## **Access Compliance Report Public Rights-of-Way** (Curb Ramps)

Intersection ID: 29916 Main Street: NORTHRIDGE DR **Cross Street: WILDBROOK DR** Location: ADA ID: 9D88317B66AB Ramp Type: PerpDiag Initial Pass/Fail: Fail **Overall Compliance: No** Severity Score: 21.25

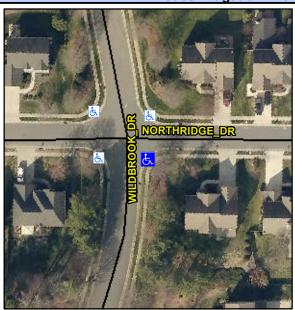
R304.5.1, R304.5.3

| Field Measurements/Component Compliance |                       |      |      |                             |      |  |
|---|-----------------------|------|------|-----------------------------|------|--|
| No                                      | Ramp Width (in)       | 40.0 | No   | Ramp XSlope (%)             | 5.2  |  |

Remove & Replace Curb Ramp With Two New Directional Ramps or Equivalent.
